**New Albany Planning Commission**  
July 15, 2024 Meeting Minutes - Approved

**MCDONALD'S  
FINAL DEVELOPMENT PLAN**

project name McDonald's - 1955 Beech Road NW  
prepared for City of New Albany  
date June 27, 2024  
date received June 13, 2024

Re: McDonald's FDP

### Site Plan

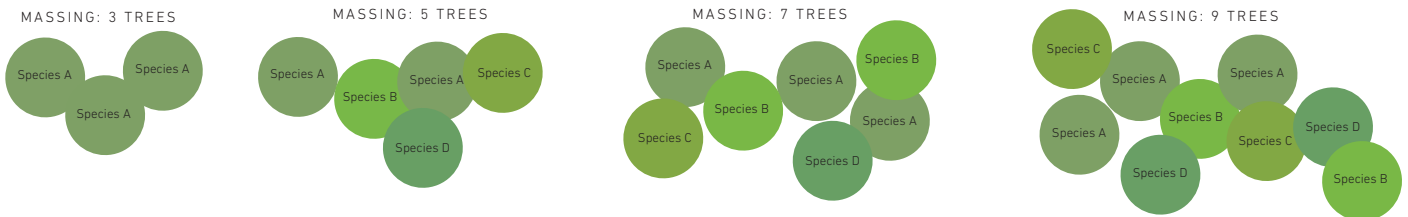
1. Further evaluation of the proposed curb cut at the access drive closest to Beech Road NW is necessary to ensure proper function and vehicular circulation. See diagram.
2. Reduce asphalt pavement width at drive through. Bypass lane to be 11'-12', reduce from the proposed 18' to 22'. See diagram.

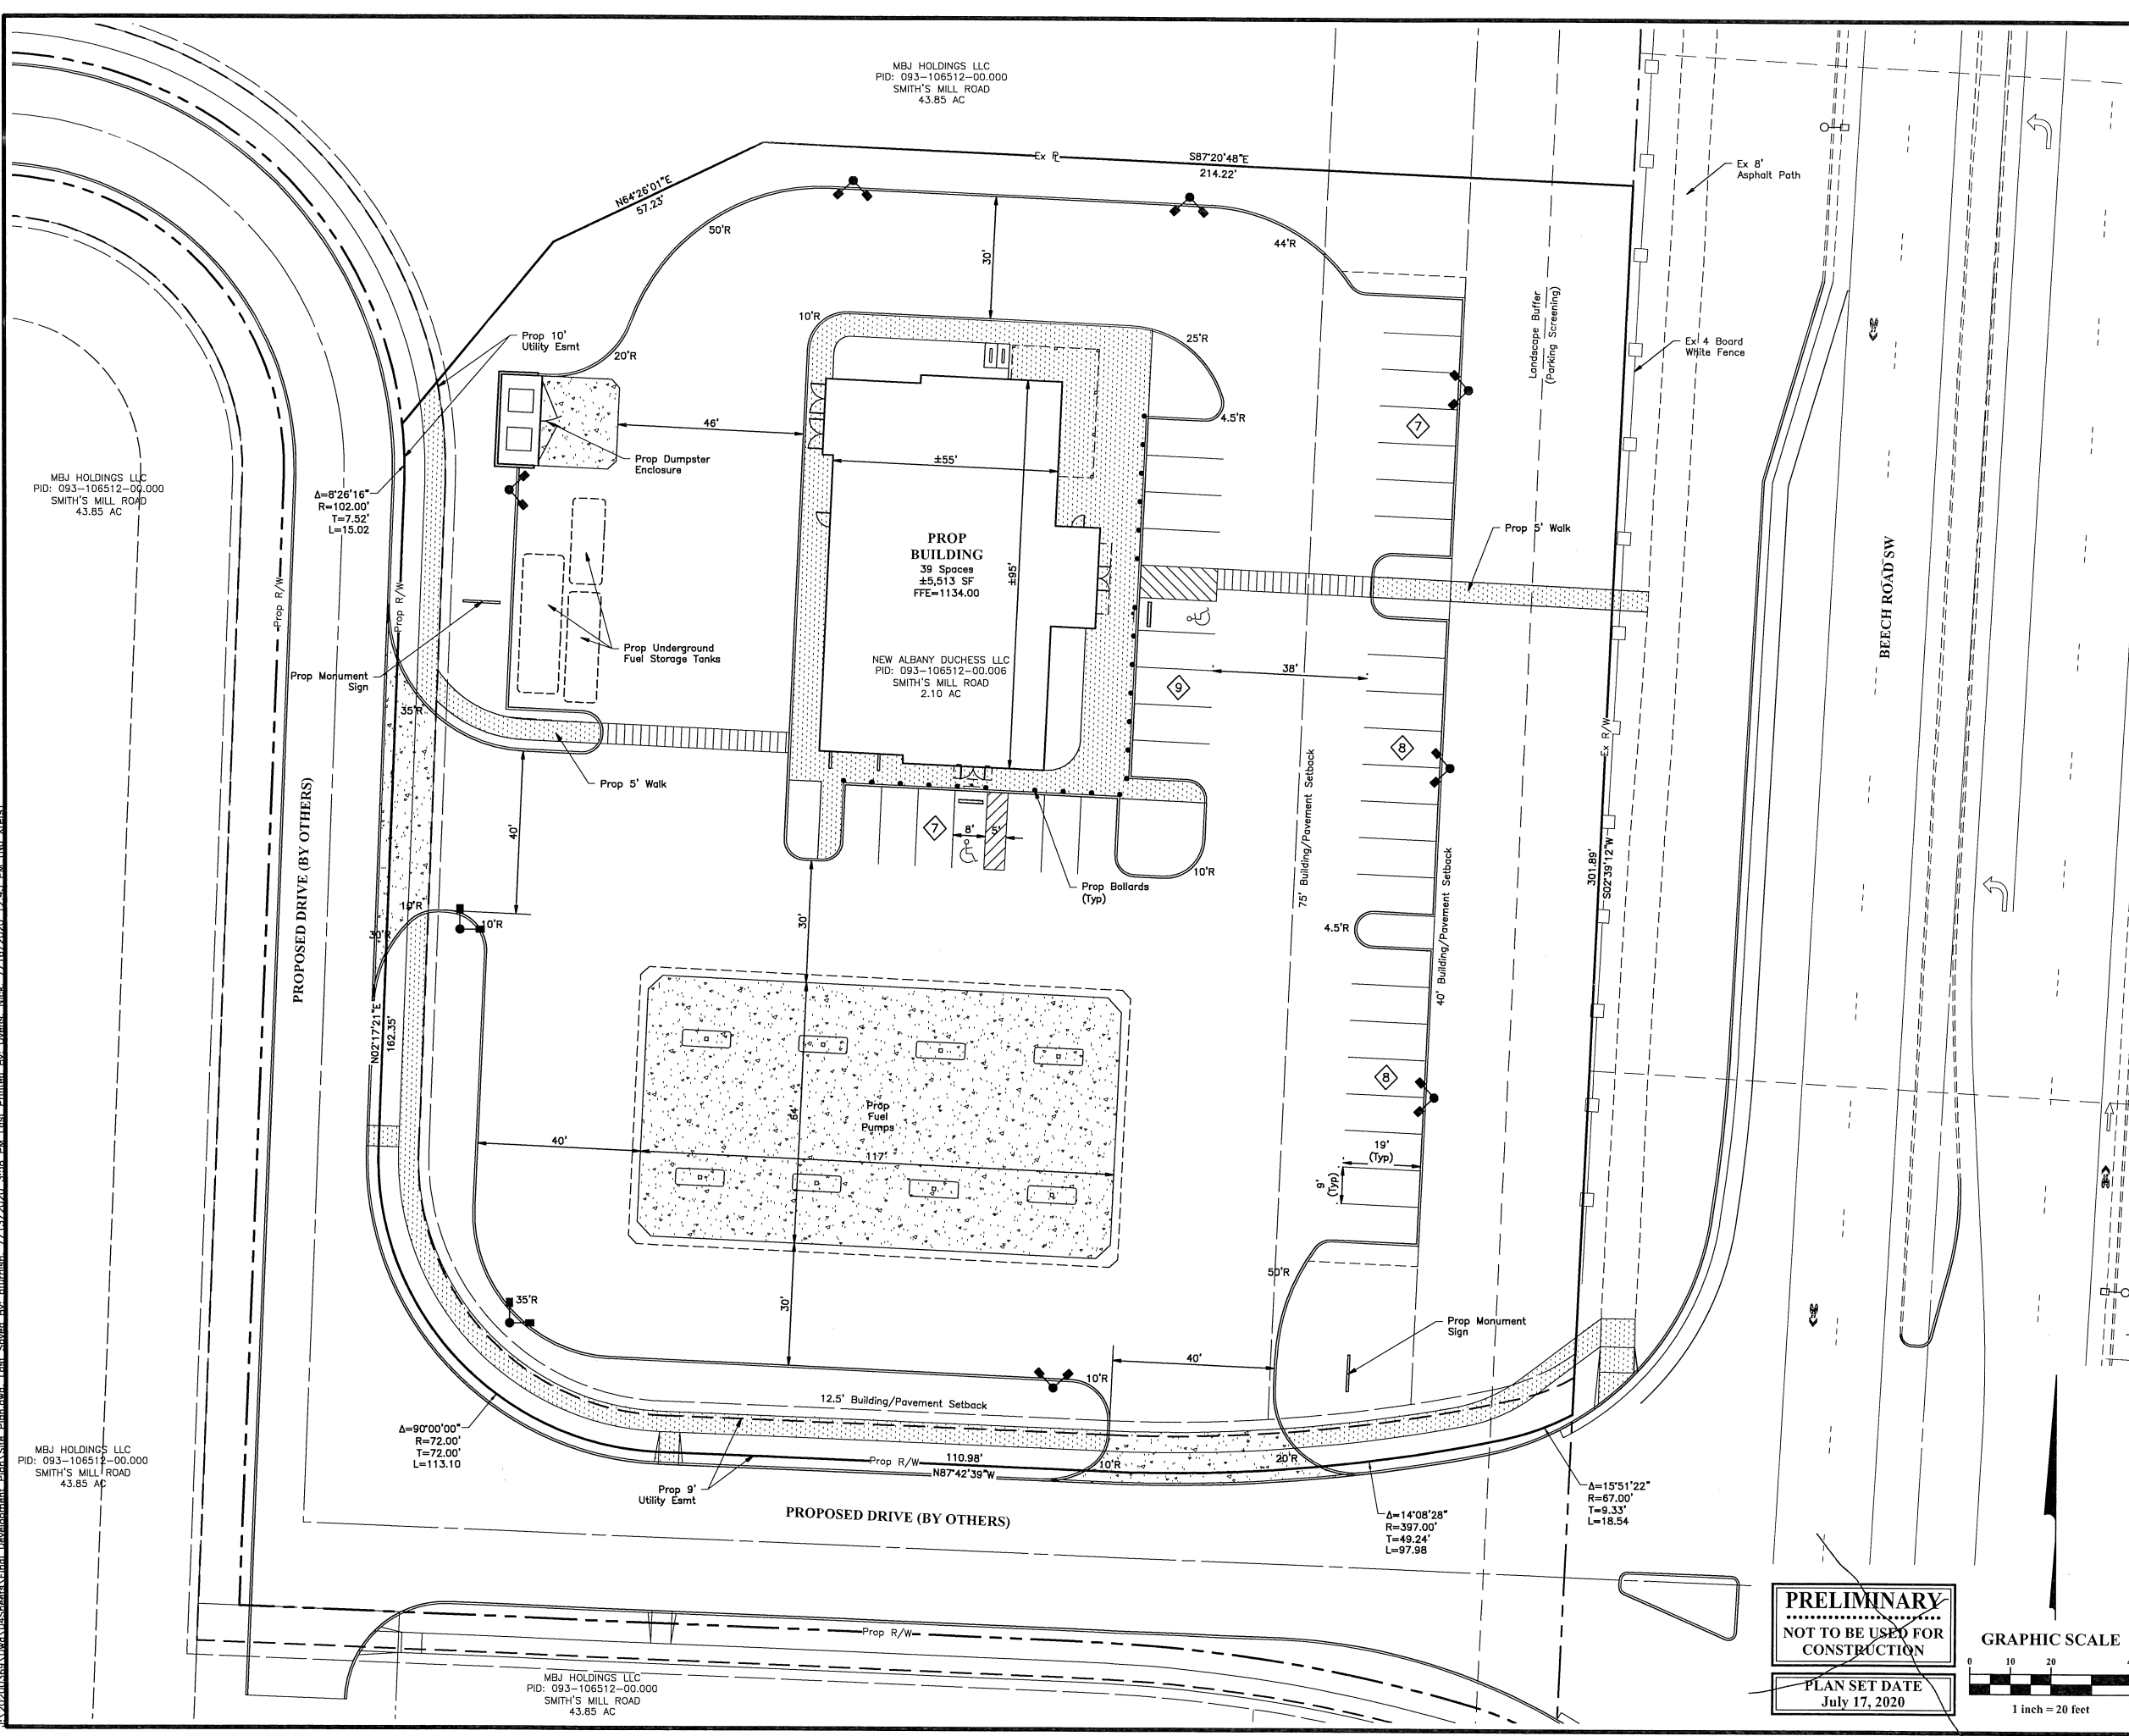
1. Refer to Exhibit A (see attached). Add the signature block shown on this exhibit and accompanying monumentation notes to the cover sheer of the referenced FDP.
